Amendment No. 1 of Specification IRS TC 76-2000   ANNEXURE-A

9.	Appendix –DC(Cl.6.9.1f) Bridging Loss measurement **Existing drawing**	
	Amended drawing

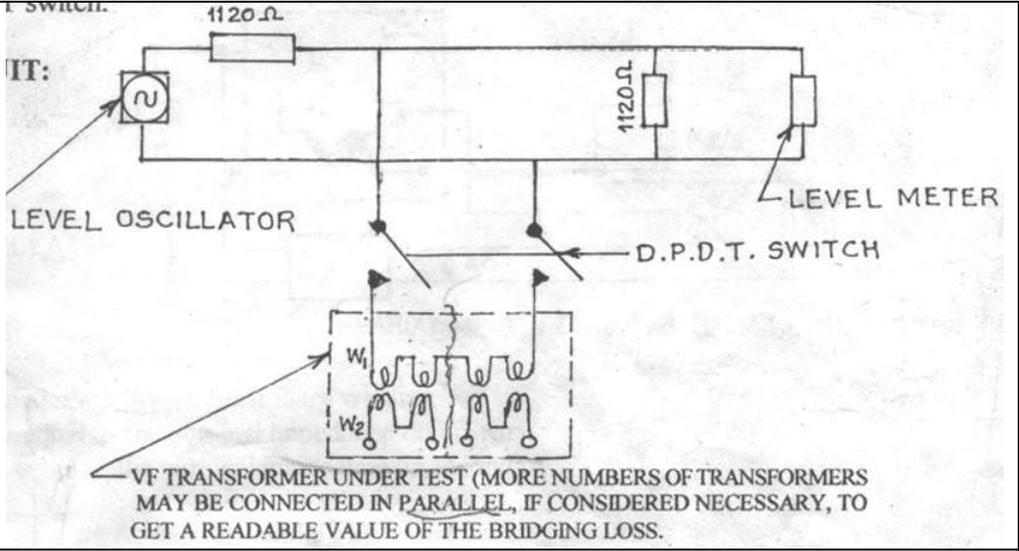
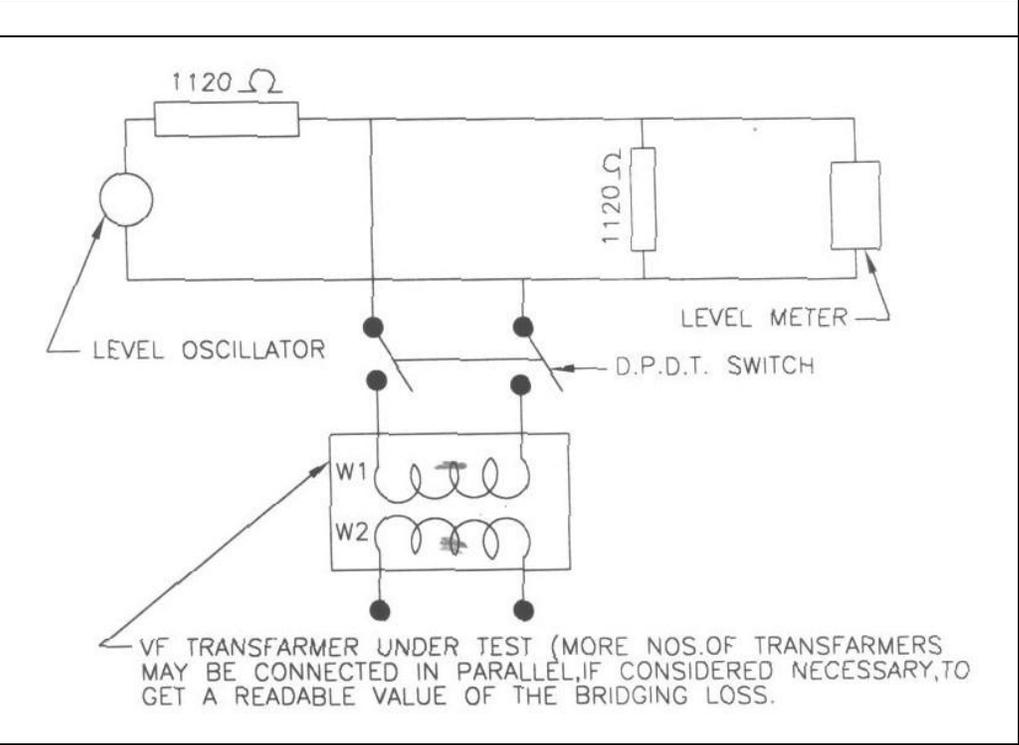
Note :Drawing has been changed as two transformers have been shown connected in series in existing drawing instead of parallel.
